TECHNICAL ADVICE – LANDSCAPE / VISUAL / NATURAL CHARACTER PEER REVIEW

**State Highway 1 North Canterbury – Woodend Bypass Project (Belfast to Pegasus)
Substantive Application
[FTAA-2512-1157]**

30th April, 2026

WOODEND BYPASS - LANDSCAPE PEER REVIEW

Figure 4. Artists impression of Pegasus Interchange, 30 years after completion of works

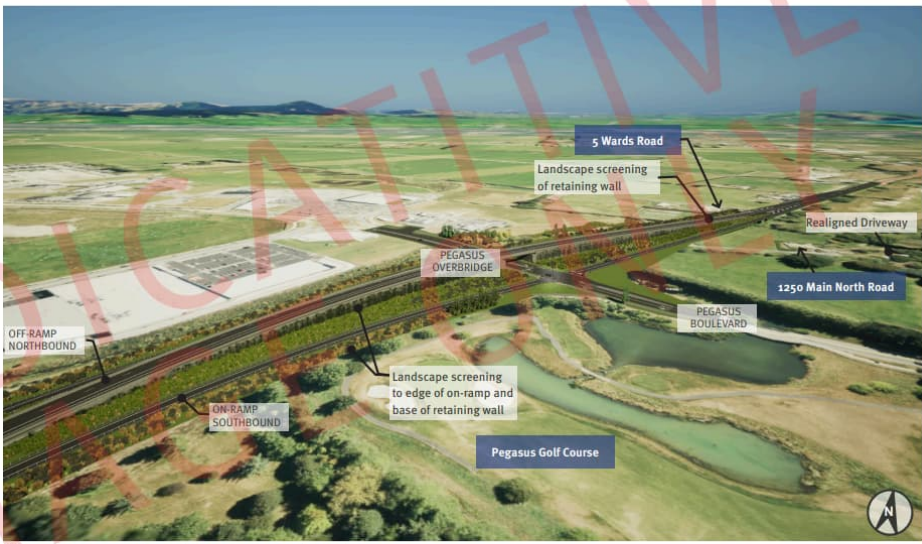
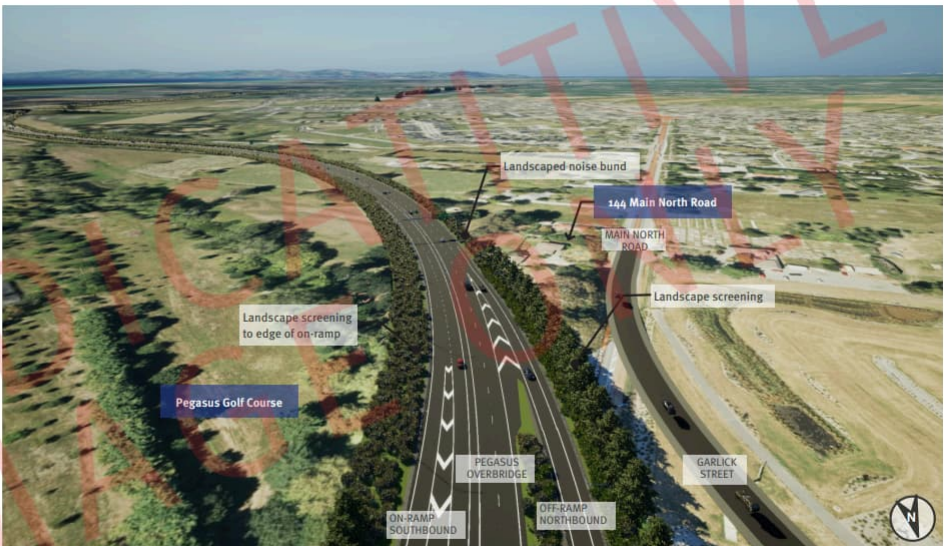
The applicant's acknowledgment that the prominence of the new vertical overpass cannot be fully mitigated is important. In my opinion, that means local residual adverse visual effects are still likely to remain, even after mitigation, particularly for:

The broad direction of effects is understandable, given that we are comparing to a previous designation that already has approval (with regards to use), but the mitigation package needs further controls through conditions to ensure council has a robust fallback in this regard- given the 30% design version is insufficient to visually show the outcome.

Appropriate controls would be showing minimum density, height and maintenance provisions for the landscape treatment. This is especially so for the east-facing and west-facing views, where stricter landscape mitigation would be appropriate. The visuals, including those recently provided (30th April 2026) are helpful at showing the landscape treatment at 10 years, but there needs to include conditions to ensure this outcome can be achieved - particularly as the visuals are 'indicative only' and cannot be relied on in full when arriving at effects conclusions.

Visual imagery at 3, 6 and 10 years, with further concept layout next to the override would allow for a level of information to enable assessment review and agreement or disagreement on effects conclusions- however this was not provided.

In my opinion, I am not confident that the level of visual effects outlined has been illustrated, particularly in the short term. 10 years, the timeframe shown in the indicative visuals, is a relatively mature height. Aside from 10 years, any robust review would need to observe simulations at:

- 1-3 years, with planting varying in height from 0.5m - 2.5m (typically).
- 3-6 years, based on information provided, with planting likely varying in height from 1.5m - 4.5m (typically).

Further landscape concept drawings should also be provided to enable assessment review, even if indicative, given the nature of the overbridge visibility. This could then be used to not only review, but flow through into conditions that have a level of control on outcome for council through the certification process.

The initial information was not yet enough information to fully close out Pegasus Interchange. Two further images have since been provided since, on 30th April, following the meeting. However, these only show landscape mitigation at 10 years- not at typical intervals during establishment where effects are typically higher.

While the direction of outcome is acknowledged and agreed, there is still not enough evidence or information at this stage for Council to assess or confirm the conclusion for effects at this stage, based on indicative imagery and limited 'establishment phase' graphics.

Information that should be sought through conditions of consent, to be able to ensure an appropriate outcome aligned with effect conclusions in the document, would be providing (at the later management plan phase):

- dimensioned sections / elevations showing structure, retaining walls, planting zones, finished landform levels, lighting and maintenance access;

- developed landscape plans (to at least 70/80% developed design version) showing concept planting structure, species, size, spacing/ density, and the intended role of any vertical mitigation elements or architectural detailing; and
- sufficient detail to confirm that the final design will be consistent with the visual mitigation outcomes claimed in the assessment.

Suggested new condition / certification trigger:
Prior to certification of the ULDMP for Pegasus Interchange, the Requiring Authority shall submit developed landscape and visual plans for the interchange, including:

- retaining wall and bridge finish details;
- planting plans with species, grade, spacing, quantity and expected mature height;
- sections showing planting depth / width relative to structures;
- soil specification and topsoil depth;
- maintenance and replacement provisions for a minimum 10-year period; and
- updated visual simulations from representative viewpoints.

Figure 1. SECTION B: Typical cross-section of landscaped earth bund (NTS)

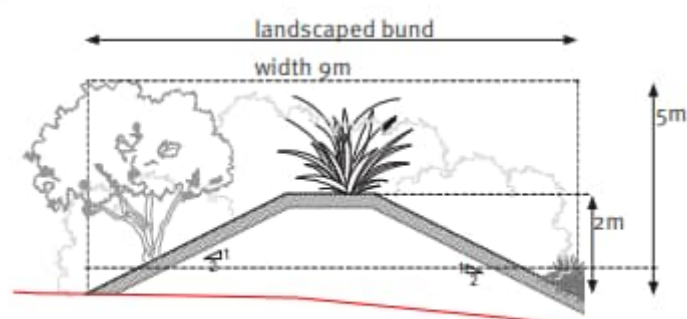
The applicant's starting point for the Lees Road CSA is supportable. Before mitigation, the temporary industrial / construction character of the CSA in the foreground view of nearby rural-residential properties is properly identified as more than minor.

This issue can likely be closed out through inclusion of specific conditions around the designed bunding, screening continuity, planting density, timing of implementation, maintenance and replacement/ remediation once disestablished. Rehabilitation should extend beyond simple surface reinstatement and should ideally address landform, soil condition, drainage and even decompaction where relevant to allow the original ground condition to be enabled.

Imagery provided above, in a follow up meeting, demonstrated that the bund is designed appropriately. Only maintenance and removal/ remedial conditions would be required.

If the proposed screening and rehabilitation conditions are tightened satisfactorily, to align with the provided indicative bund and landscape cross section above, this can be closed out (in agreement with effects and mitigation proposed).
